EUROPEGAS VER. 2.12 SOFTWARE CHANGES DESCRIPTION

We have discovered following problem in PLUS/OBD CAN software ver. 2.0.9.

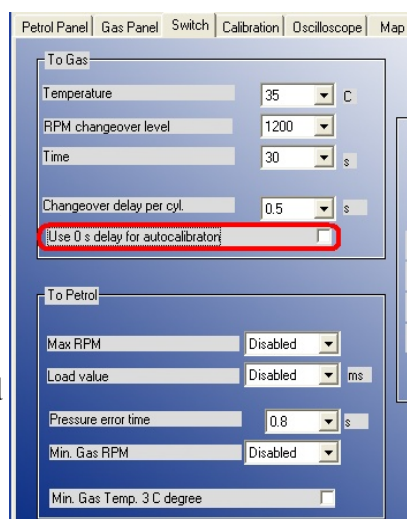
Sometimes after pressing the AUTOCALIBRATION button or any of ICONS on the top side of the program window nothing happens.

There was a minor bug in version 2.0.9 of PLUS/OBD CAN application which sometimes placed the active window (like waiting for pressing "OK") button or opening a icon window (like "Correction") below Main program window. In result You might experience situation when the active window waits below Main window and You are not able to do anything with the application window because Active window is not visible. Application which I'm sending to You in attachment fixes that bug and brings few new things (upgrades):

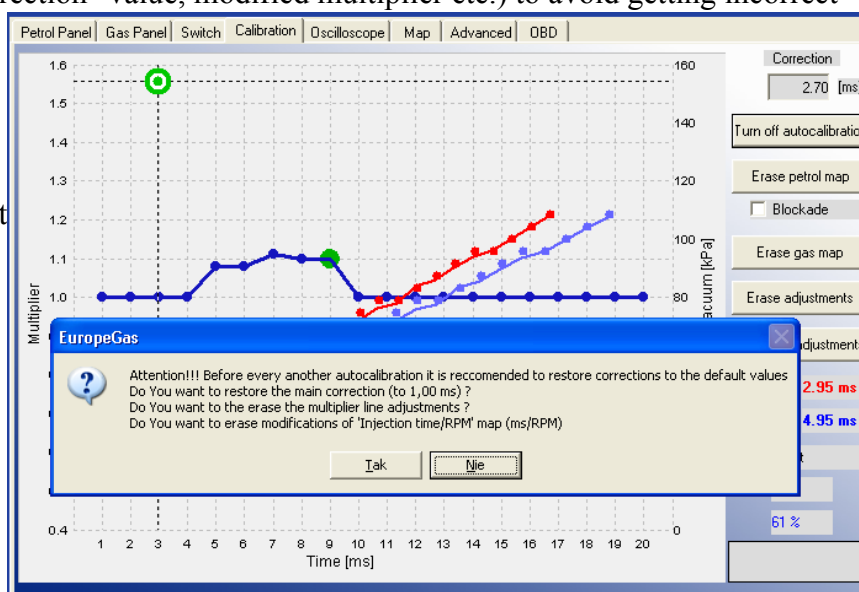
2) As You know before every another autocalibration it is necessary to erase all corrections made by the user (like high "Main correction" value, modified multiplier etc.) to avoid getting incorrect correction after

Autocalibration process.

Now You are automatically reminded to do this if software would detect that any of corrections is different from the standard settings (Main correction different from 1,00 ms, Multiplier different from 1,00, Any field on RPM/ms map different from 0%)
